DESIGN BULLETIN

1. **Design** DB/03/2013/06
2. **bulletin no.**
2. **Subject** Modification in electrical circuit to avoid discharge of battery in HHP locos due to repeated cranking.
3. **Background** In the existing electrical circuit, if fuel pump motor fails and cranking is attempted, starting motors starts drawing current and discharge the battery. In addition when EFCOR is in denergised/ drop out condition (open circuit of coil, defective NC interlock of SDR (Shut Down Relay) and open circuiting of wire from SZ6 wire to EFCOR coil), the starting motor shall draw current if cranking is attempted.

EFCO circuit modification for avoiding draining of battery

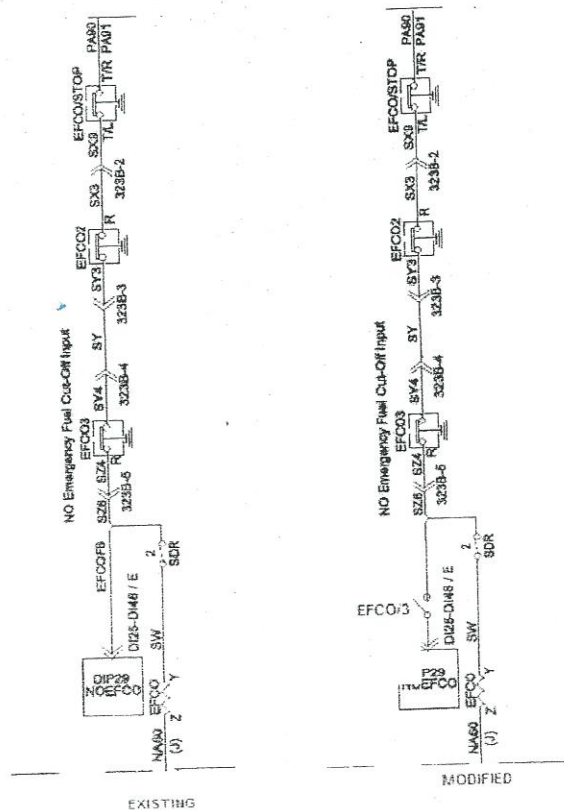
During analysis, it is noted that even if EFCOR is open circuited, digital input signal (NO EFCO FEEDBACK) shall be available to LCC; which permits the engine to crank, but firing shall not take place because DV solenoid shall be in energised condition. This causes draining of battery due to repeated cranking.

Above issue has also been discussed with RDSO during meeting on 26.07.013 and decided to modified the circuit as suggested by GOC/Shed.

NO interlocks of EFCOR is to be connected in series with EFCO push button switch NC interlocks EFCO1, EFCO2 and EFCO3 feeding supply Digital input signal (NO EFCO) to MLCC.

By implementing this circuit modification, cranking can be prevented during the occasions such as EFCOR coil open circuit, SDR NC interlock defect.
